Tennessee Valley Authority, 1101 Market Street, BR 2C, Chattanooga, Tennessee 37402-2801

TENNESSEE VALLEY AUTHORITY (TVA) – SEQUOYAH NUCLEAR PLANT (SQN) – NPDES PERMIT NO. TN0026450 – AMENDED PERMIT APPLICATION – REQUEST TO CONDUCT A PREDICTIVE CLEAN WATER ACT (CWA) SECTION (§) 316(a) DEMONSTRATION

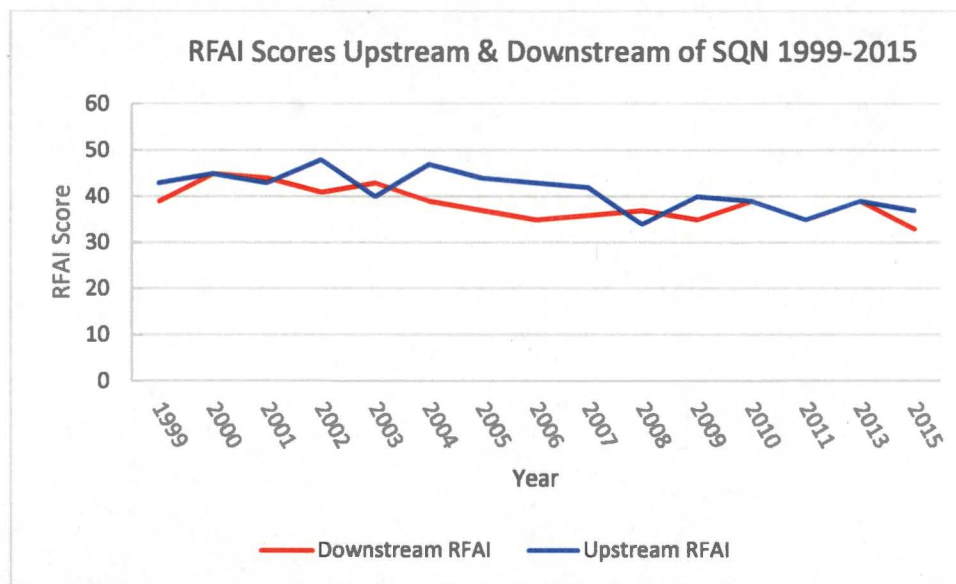
TDEC Comment: "Moreover, even if the anti-backsliding provisions of our rules weren't controlling, we additionally have significant reservations about the appearance of a decline in reservoir ecological health both upstream and downstream from the Sequoyah Plant."

TVA Response: TDEC provided a graphic prepared by its Water Resources Division based on TVA-reported Reservoir Fish Assemblage Index (RFAI) scores for Chickamauga Reservoir from 1999 to 2015 showing a slight, but discernible, downward trend in score values for sampling stations upstream and downstream of SQN.

TVA has reproduced the graphic prepared by TDEC below¹:

As TDEC noted, the observed trend of declining RFAI scores from 1999 through 2015 is present at both the upstream and downstream locations. Importantly, this is an indication that SQN operation, specifically the thermal discharge, is not the likely causative factor for the decline.

As presented at our meeting on November 13, 2019, the observed trend in RFAI scores for the period 1999-2015 is statistically significant ($p < .05$); however, that has not been the case for over a decade (since 2006) where RFAI scores at both locations have remained relatively stable (i.e., no statistically significant declining trends for 2006-2017).
